Subject: Draft Final Technical Study of Spent Fuel Pool Accident Risk at
Decommissioning Nuclear Power Plants, February 22, 2000 (65 F.R.
8752), Request for Comments

**Industry Comments
NRC Draft Final Technical Study of
Spent Fuel Pool Accident Risk at
Decommissioning Nuclear Power Plants**

**Comments on Appendix 2.b.
"Structural Integrity Seismic Loads"**

Figure 1 – Distribution of Upper Bound Magnitude Estimates from Reference 2 for a New England site.

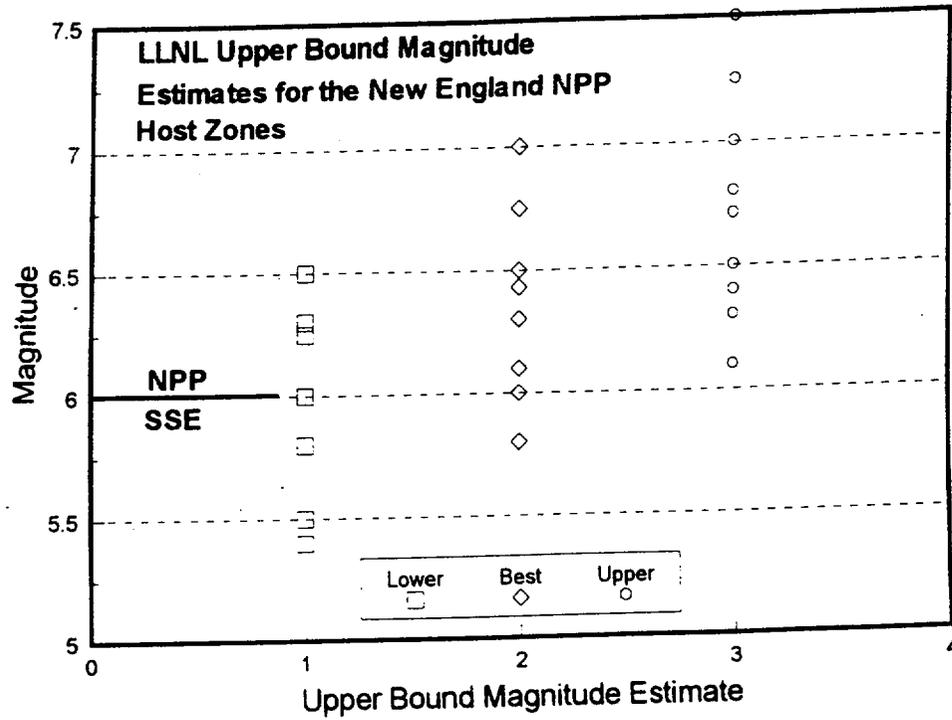
References 2 and 3 describe the Lawrence Livermore National Labs (LLNL) and Electric Power Research Institute (EPRI) seismic hazard methodologies. A seismic hazard analysis (SHA) estimates the seismic hazard at a site due to the potential occurrence of earthquakes in the region surrounding the site. Importantly, the historic seismic data is insufficient, at least for the CEUS, to use as the sole source of information for estimating the various parameters of the overall probability model. Therefore, it is necessary to rely on "expert opinion" to supplement the data. One fundamental expert opinion input to the SHA is the upper bound magnitude distribution for each earthquake source. Figure 1 contrasts the distribution of upper bound magnitude estimates assessed by the experts in the LLNL study for the host zones containing a New England NPP with the SSE determined by the 10CFR Part 100 Appendix A process. This distribution of upper bound magnitude may be plausible, but not necessarily a possible outcome. In other words, it is not based on any known structure in each host zone description that could cause earthquakes this large. Within this context, the assessed seismic hazard will generally be higher – because less is known and the distribution has more probability associated with extreme outcomes, or, outcomes that in fact cannot occur. The effect of including these extreme outcomes is to predict incredible ground motions at credible probability levels. Expert opinion on the distribution of upper bound magnitude is but one of the many opinions rendered in the LLNL and EPRI studies that have profound effects on the perceived seismic hazard at low (10^{-6}) probability levels.

Figure 2 Effect of Attenuation Random Uncertainty on Probability of Exceedance from a Point Source

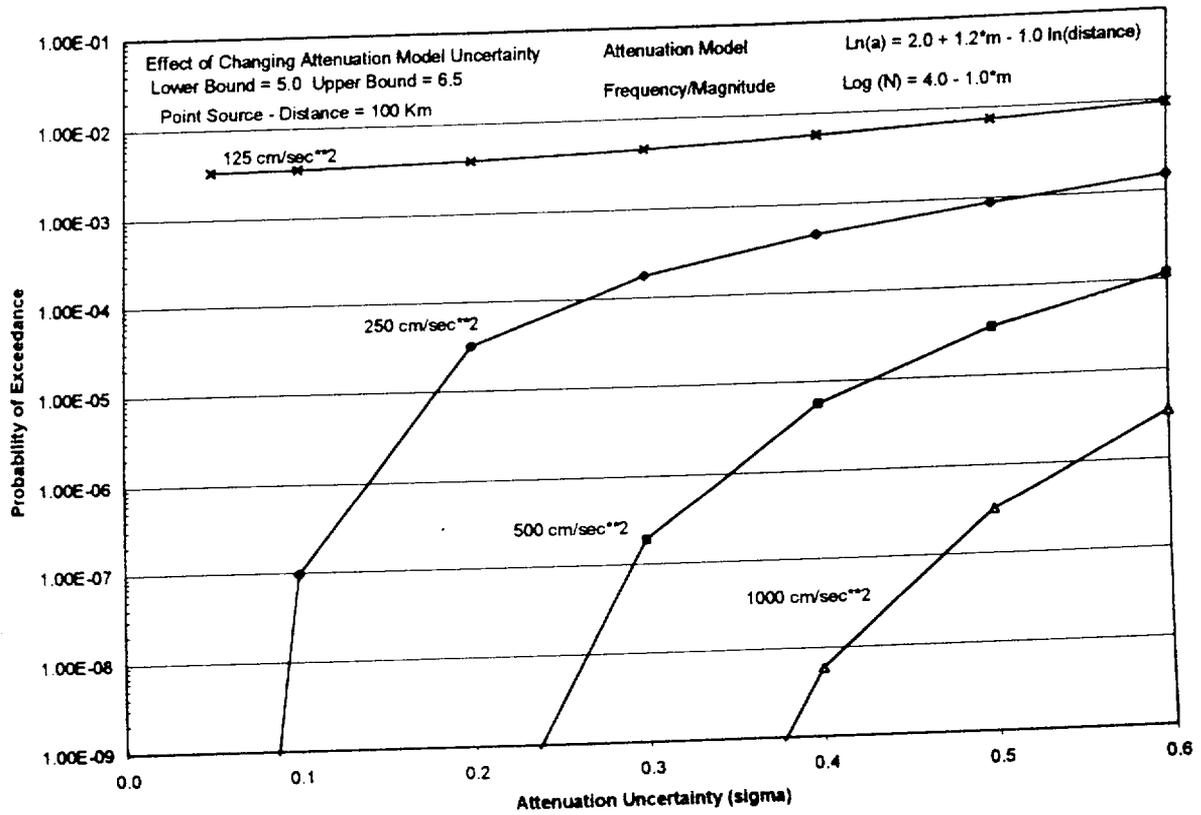
Successful application of the revised seismic checklist provides a high degree of assurance that the SFP HCLPF is 0.5g or greater. It is noted that given a HCLPF of 0.5g the median capacity of an SFP is about 1.0g. Realistically, only large Charleston like earthquakes can generate ground motions of the amplitude, frequency content, and duration to challenge the seismic capacity of spent fuel pools. In no EUS licensing proceeding has there been compelling data to require design to an earthquake of a magnitude which would challenge the seismic capacity of an SFP that satisfies the seismic checklist. The focus of previous seismic hazard studies (LLNL and EPRI) has been at the SSE level. At high ground motion values (ground motion values that can be associated with damage to SFPs), the tail of the attenuation random uncertainty distribution (sigma) allows, with some non-negligible probability, relatively small events to contribute to the

probability of exceeding these high ground motion values. These results don't make sense and provide a basis for truncating the tail of the random uncertainty term at high ground motion values. In deterministic analyses used in the licensing of existing NPPs, one standard deviation is considered sufficient to incorporate all the conservatism in the final ground motion estimate. Based on this information and information previously described in Reference 5, use of the LLNL probabilistic estimates at low probability values may not be credible. EPRI results are also likely to be overly conservative at high ground motion values.

Figure 3 – Annual Probability of Exceeding the SSE at CEUS sites based on EPRI (Reference 3)

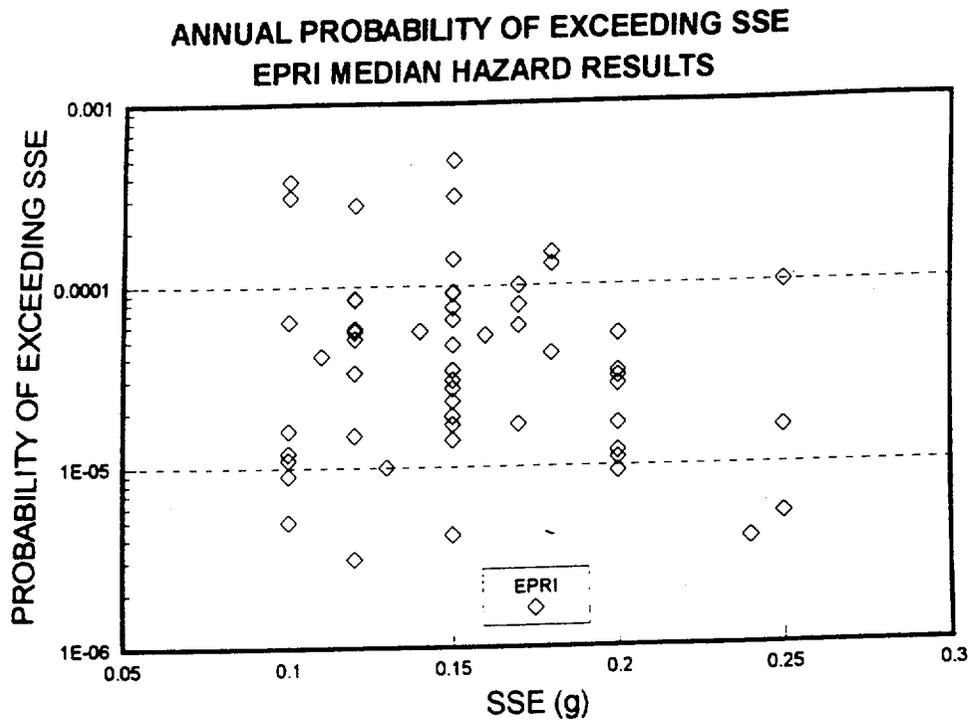
The staff concludes that for those CEUS plants where 3 X SSE is less than or equal to the NEI screening criterion of 0.5g, then the seismic risk is acceptable low. A similar conclusion is reached for those WUS plants where 2 X SSE satisfies the screening criterion. For CEUS plants that exceed the 3 X SSE screening criterion, a detailed SFP assessment will be required to demonstrate the SFP HCLPF equals 3 X SSE. A similar conclusion is reached for those WUS plants where 2 X SSE exceeds the screening criterion. This requirement that some plants with higher SSE values perform detailed HCLPF assessments of their SFPs is not warranted. The assumption of this requirement is that the SSE is correlated with seismic hazard, in other words, the higher the SSE the higher the seismic hazard. Previous studies have shown that the SSE is poorly correlated with the seismic hazard (see Figure 3). In particular, there are many 0.2g to 0.25g SSE sites with lower seismic hazard estimates than 0.1g to 0.2g SSE sites. SSE tends to be more correlated with plant vintage than seismic hazard. **Based on this information, we**
